SUBJECT: Resource Conservation and Recovery Act Facility Investigation Work Plan for Solid Waste Management Unit WP-26, Sewage Lagoons and Golf Course Main Pond

1. The Environmental Management (EM) Branch at Kirtland Air Force Base (KAFB) is submitting replacement pages for the subject report, originally submitted to you 27 Jul 04. Included is one electronic version of the revised document.

2. The revised pages are 2-7, 2-10, 2-11, 3-3, 3-8, 3-9, 3-10, 4-1, B-10 and the Table of Contents. The revisions resulted in changes to intermediate pages that are also included. Installation of the soil vapor monitoring points within the sixteen Direct Push Technology (DPT) boreholes, analyses of the soil vapor samples collected from the sixteen DPT boreholes and the frequency of soil sampling during installation of the two boreholes installed using the Air Rotary Casing Hammer (ARCH) drilling method have been modified.

**Figure 2-2. Proposed Locations of Soil Gas Monitoring Points for the *Resource Conservation and Recovery Act* Facility Investigation at Solid Waste Management Unit WP-26 Kirtland Air Force Base, New Mexico**

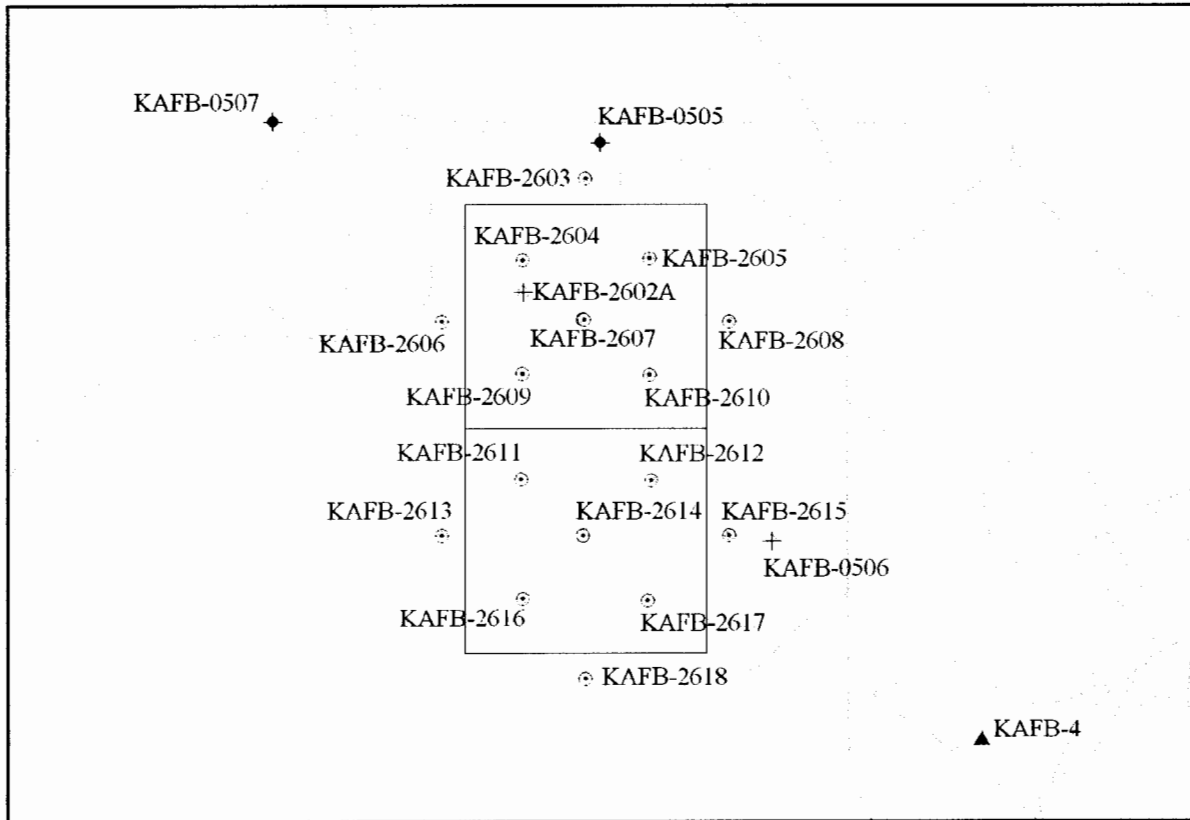
3. The original plan proposed real-time soil vapor sampling and analyses during installation of the pilot DPT soil boring to determine the placement of three soil vapor monitoring points in the final DPT soil boring. This plan would require use of an on-site laboratory. The revised plan proposes to install five soil vapor monitor points at predetermined depths in the DPT soil boring and use of an off-site laboratory for the analyses. The change is due to the potential for incomplete closure of the soil vapor sampling port during the DPT drilling process in the pilot borehole and the consequent inability to continue with the soil boring. Predetermined depths for setting the soil vapor monitor points within the DPT boreholes will avoid the potential problem. Additionally, the original plan required installation of a pilot and final DPT soil borehole, while the revised plan requires a single DPT borehole, resulting in a more efficient process.

A soil gas survey will be performed by installing nested multi-depth soil gas sampling points. Sixteen boreholes will be drilled using direct-push technology (DPT) to an estimated depth of 100 to 125 ft below ground surface (bgs) (Figure 2-2). Five soil vapor monitoring points will be installed within each of the DPT boreholes every 25 feet (25, 50, 75, 100, and 125 ft bgs). The soil vapor monitoring points will be allowed to equilibrate with the subsurface for one to two weeks then soil gas samples will be collected in Summa® canisters from each monitoring point. The soil gas samples will be analyzed for VOCs by EPA Method TO-15 (EPA, 1999) using an offsite laboratory.
